H. B. ROBINSON UNIT 2
FACILITY OPERATING LICENSE DPR-23
APPLICATION FOR OPERATION AT 2300 MWt CORE POWER

REVISIONS TO TECHNICAL SPECIFICATIONS

H. B. ROBINSON UNIT NO. 2

2300 MWt CORE POWER OPERATION

Figure 2.1-1
Protection Boundaries
N-Loop Operation

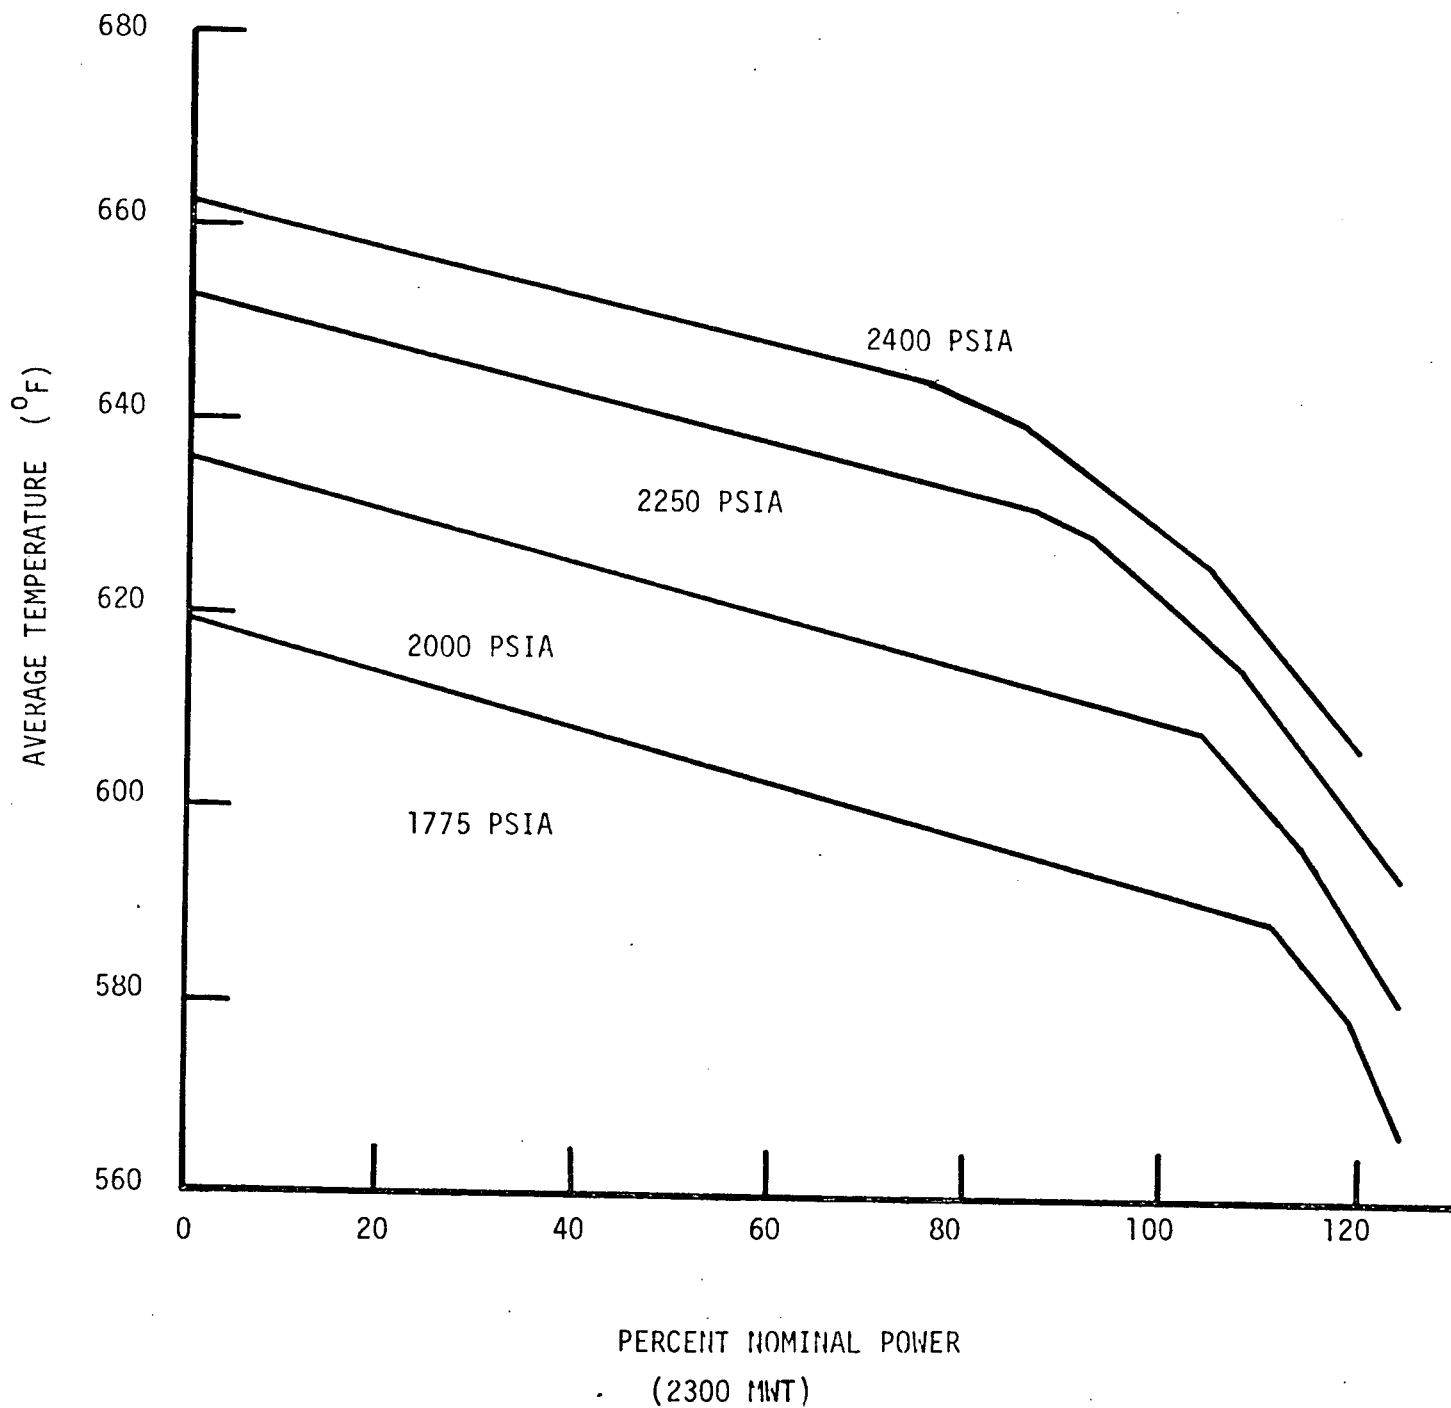
- a. The combination of thermal power level, coolant pressure, and coolant temperature shall not exceed the limits shown in Figure 2.1-1 when full flow from three reactor coolant pumps exists and shall not exceed the limits shown in Figure 2.1-2 when the full flow from two reactor coolant pumps exists.

The curves of Figure 2.1-1 which show the allowable power level decreasing with increasing temperature at selected pressures for constant flow (three loop operation) represent the loci of points of thermal power, coolant system average temperature, and coolant system pressure for which the DNB ratio is not less than 1.30. The area where clad integrity is assured is below these lines. In order to completely specify limits at all power levels, arbitrary constant upper limits of average temperature are shown for each pressure at powers lower than approximately 75%. The temperature limits at low power are considerably more conservative than would be required if they were based upon a minimum DNB ratio of 1.30 but are such that the plant conditions required to violate the limits are precluded by

The curves of Figure 2.1-2 which show the allowable power level decreasing with increasing temperature at selected pressures for constant flow (two loop operation) represent the loci of points of thermal power, coolant system average temperature, and coolant system pressure for which either the DNB ratio is equal to 1.30 or the average enthalpy at the exit of the core is equal to the saturation value. At low pressures or high temperatures the average enthalpy at the exit of the core reaches saturation before the DNB ratio reaches 1.30 and, thus, this arbitrary limit is conservative with respect to maintaining clad integrity. In order to completely specify limits at all power levels, arbitrary constant upper limits of average temperatures are shown for each pressure at powers lower than approximately 40%. The limits at low power as well as the limits based on the average enthalpy at the exit of the core are considerably more conservative than would be required if they were based upon a minimum DNB ratio of 1.30. The plant conditions required to violate these limits are precluded by the protection system and the self actuated safety valves on the steam generator. An upper limit of 70% for power is shown to completely bound the area where clad integrity is assured. This latter limit is arbitrary but cannot be reached due to the permissive 8 protection system setpoint which will trip the reactor on high nuclear flux when only two reactor coolant pumps are in service. Additional peaking factors to account for local peaking due to fuel rod axial gaps and reduction in fuel pellet stack length have been included in the calculations of the curves shown in Figures 2.1-1 and 2.1-2. The figures also include the effects of uprating to 2300 MWt.⁽⁴⁾

The overpower and overtemperature protection system setpoint have been revised to include effects of fuel densification and the increase in rated thermal output to 2300 MWt on core safety limits. The revised setpoints in the Technical Specifications insure the combination of power, temperature, and pressure will not exceed the core safety limits as shown in Figures 2.1-1 and 2.1-2.

Figure 3.10-2

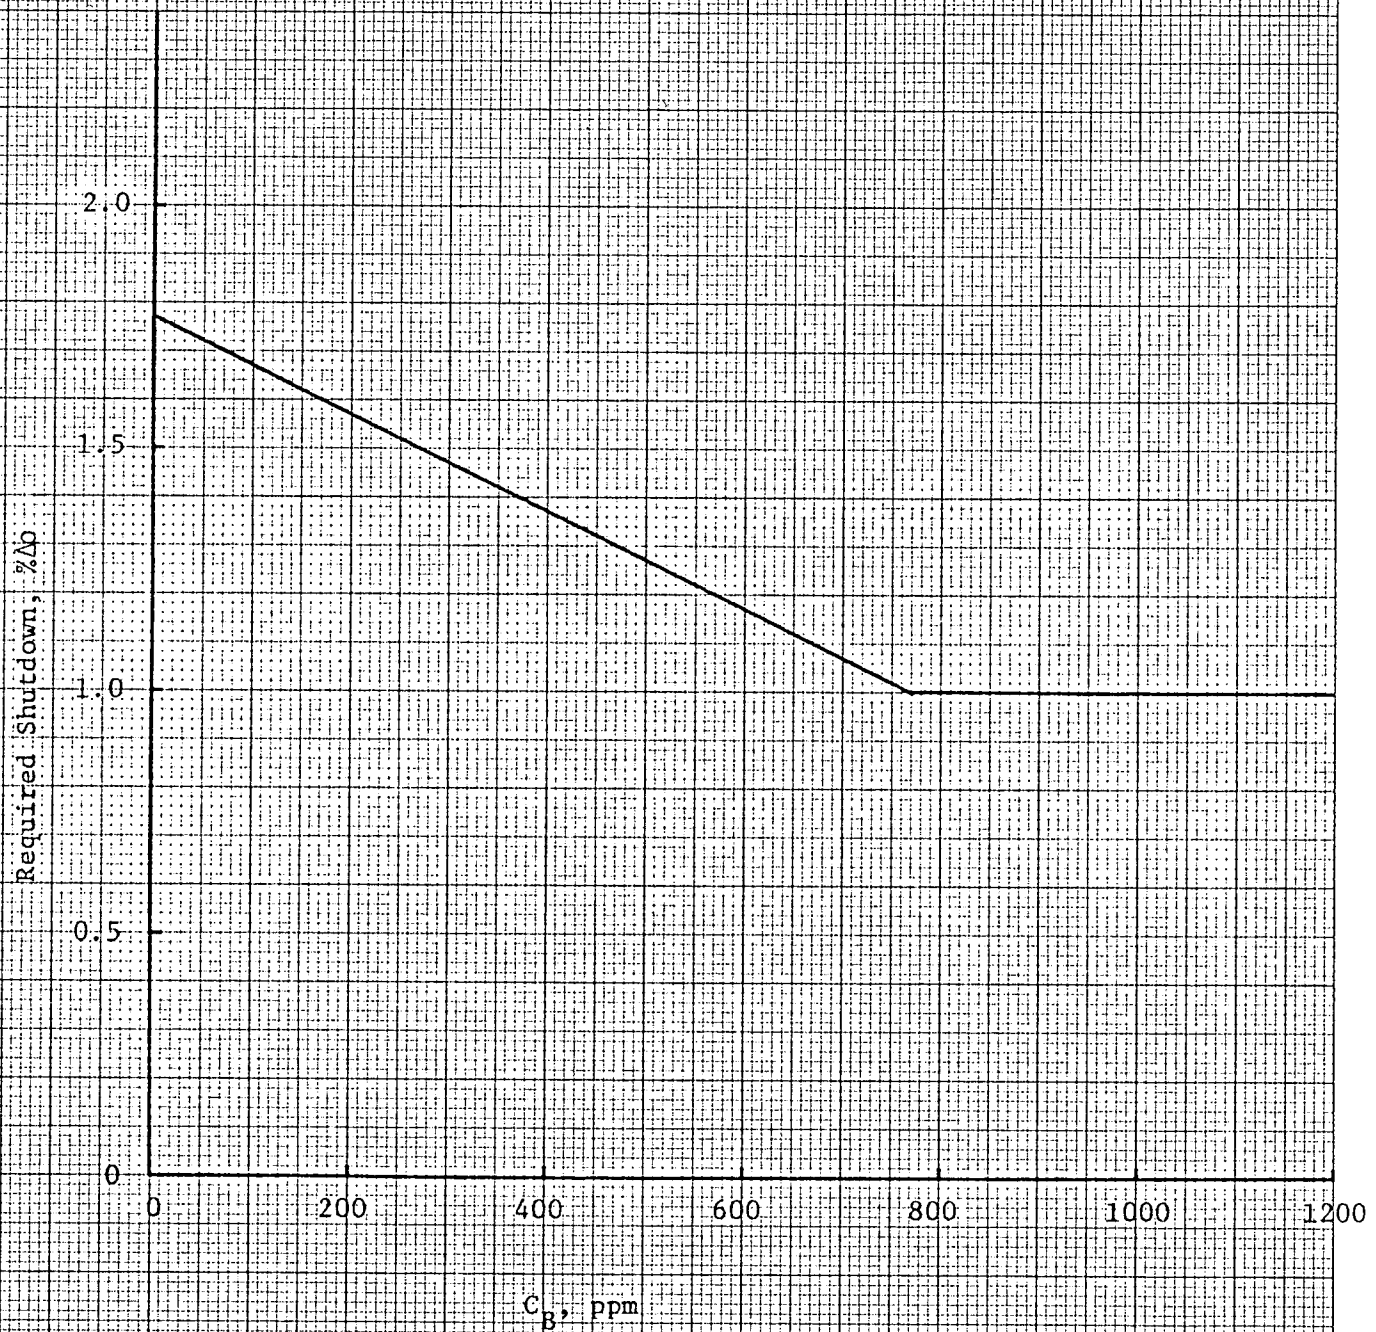
3.10.1.6 Insertion limits do not apply during physics tests or during periodic exercise of individual rods. However, the shutdown margin indicated in Figure 3.10-2 must be maintained except for the low power physics test to measure control rod worth and shutdown margin. For this test the reactor may be critical with all but one full length control rod inserted and part length rods fully withdrawn.

- 3.10.8.1 When the reactor is in the hot shutdown condition, the shutdown margin shall be at least that shown in Figure 3.10-2.
- 3.10.8.2 When the reactor is in the cold shutdown condition, the shutdown margin shall be at least 1% $\Delta k/k$.
- 3.10.8.3 When the reactor is in the refueling operation mode, the shutdown margin shall be at least 10% $\Delta k/k$.

Figure 3.10-3
Power Spike Factor Versus Elevation

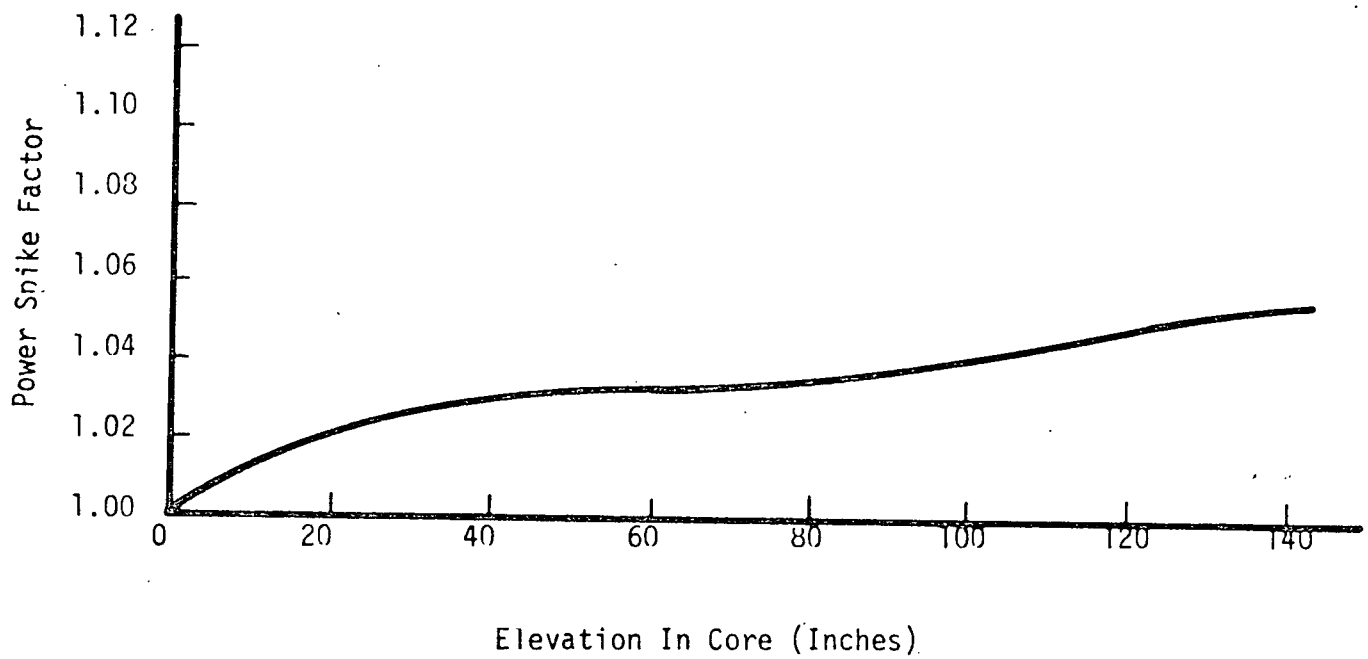
The measured value of $F_{\Delta H}^N$ must be additionally corrected by including a penalty as shown in Figure 3.10-3 (at the appropriate core location) to account for fuel densification effects before comparison with the limiting value above.
